Form C-103
May 27, 2004

7. Lease Name or Unit Agreement Name
RINCON UNIT

8. Well Number #505

SUNDRY NOTICES AND REPORTS ON WELLS
(DO NOT USE THIS FORM FOR PROPOSALS TO DRILL OR TO DEEPEN OR PLUG BACK TO A DIFFERENT RESERVOIR USE "APPLICATION FOR PERMIT" (FORM C-101) FOR SUCH PROPOSALS.)

RINCON LATERAL 84 CDP
95 BBL SUMP
DETAILS

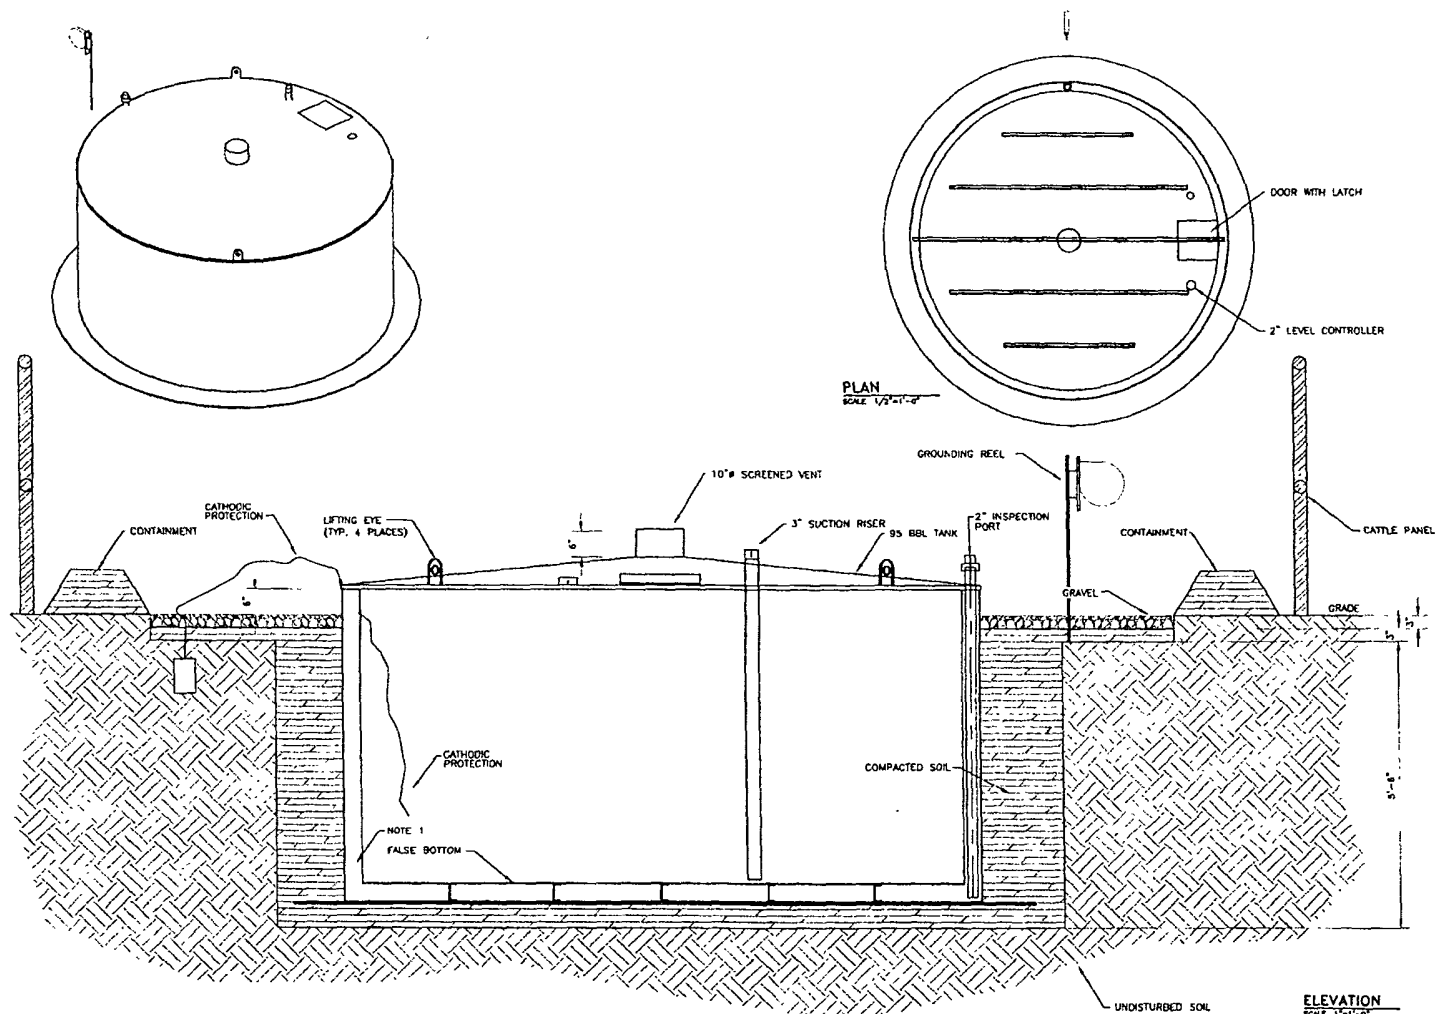
Chevron MidContinent, L.P. reports that we have changed our planned facilities for the above mentioned location. A ~400 BBL steel tank, a ~95 BBL below-grade steel tank, a separator, and an Enterprise meter run will be installed on the well pad. Attached is a basic diagram of how these facilities would be arranged on a wellsite and a basic diagram of the 95Bbl below-grade steel tank. Should you have any questions or require any additional information, please feel free to contact us at anytime.
